COMMUNITY DESIGN REVIEW BOARD STAFF REPORT
Meeting Date October 21, 2025

REPORT TO: Michael Sable, City Manager
REPORT FROM: Elizabeth Hammond, Planner
PRESENTER: Elizabeth Hammond, Planner
AGENDA ITEM: Design Review and Parking Waiver Resolution, Seven Brews Coffee, 2982 White Bear Avenue North

Engineering Plan Review

PROJECT: **Seven Brew Coffee**
 2982 White Bear Avenue

C2.1
 SITE PLAN
 DATE: AUGUST 14, 2023

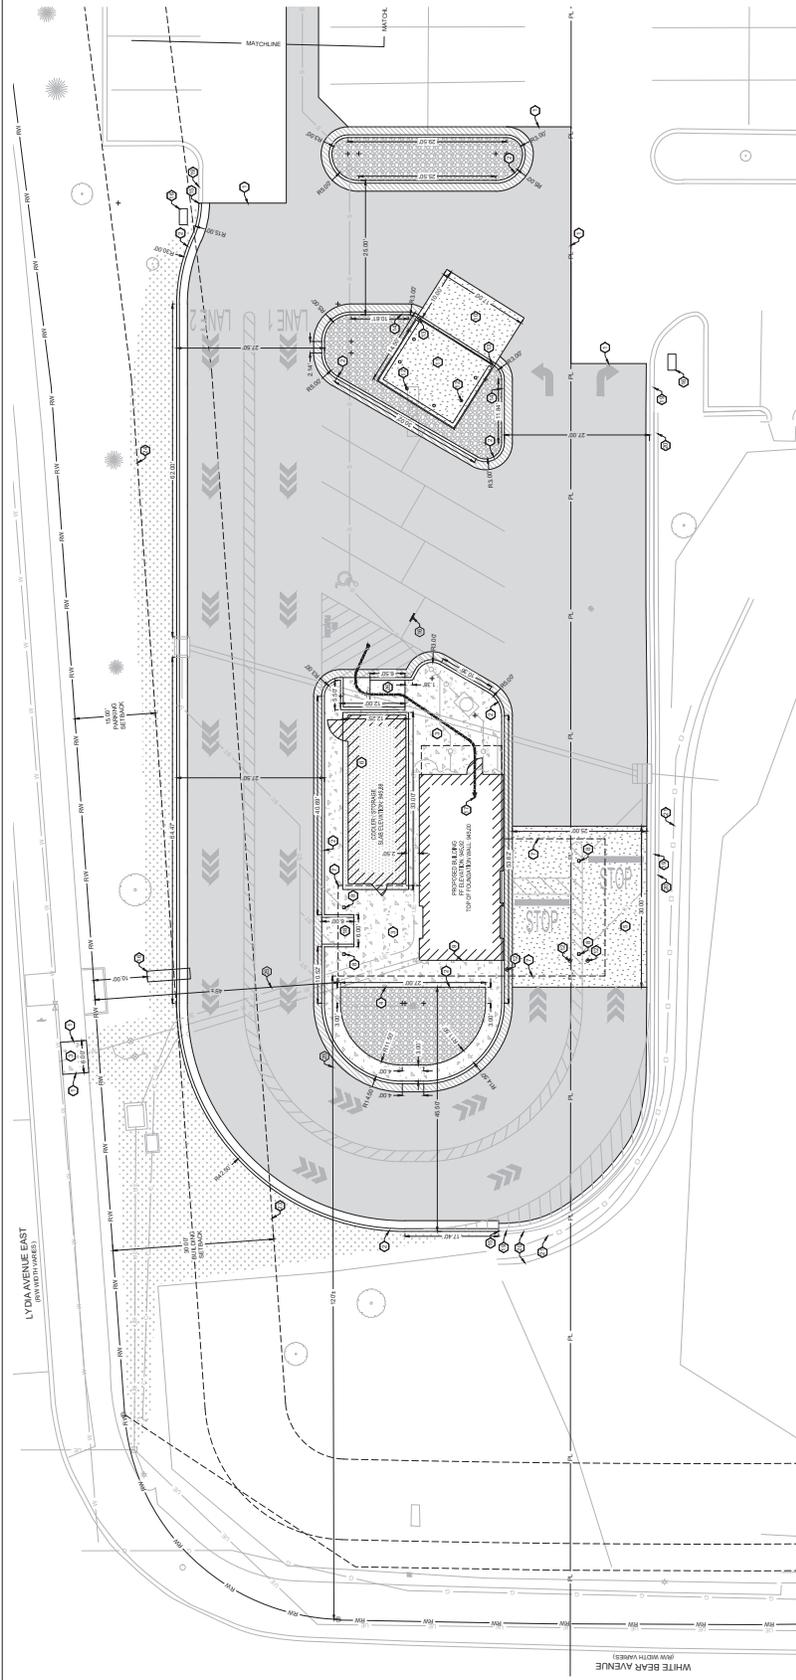
The parking and building setbacks are achieved to the north, west, and east property lines. However, the current plan shows the parking lane and canopy for the coffee stand encroaching on the south property line, which runs through the existing parking lot from White Bear Avenue and the building between Half Price Books and Michaels. Before obtaining a building permit, the applicant must submit a lot division application to adjust the south lot line or prepare an easement for review by the city.

- 1) The site plan shows that the canopy projects over the property line and the support columns are on the adjacent property, which is not permitted by the building code.

- a. The applicant must apply for a lot division to adjust the property line or prepare an easement for review by the city.
- 2) The site plan must be updated to confirm that the accessible parking space is provided with an access aisle meeting the requirements of the Minnesota Accessibility Code Section 502.4 (Minnesota Rule 1341.0502 Subpart 2).

- b. The applicant must provide a tree preservation plan and an updated landscape plan as outlined in the environmental review comments.
 - c. The applicant must submit for review a lot division application addressing the encroachment over the south property line. The canopy structure cannot extend over the property line. The applicant can prepare an easement for the encroachment, which must be provided to the city for review, or apply to adjust the lot line.
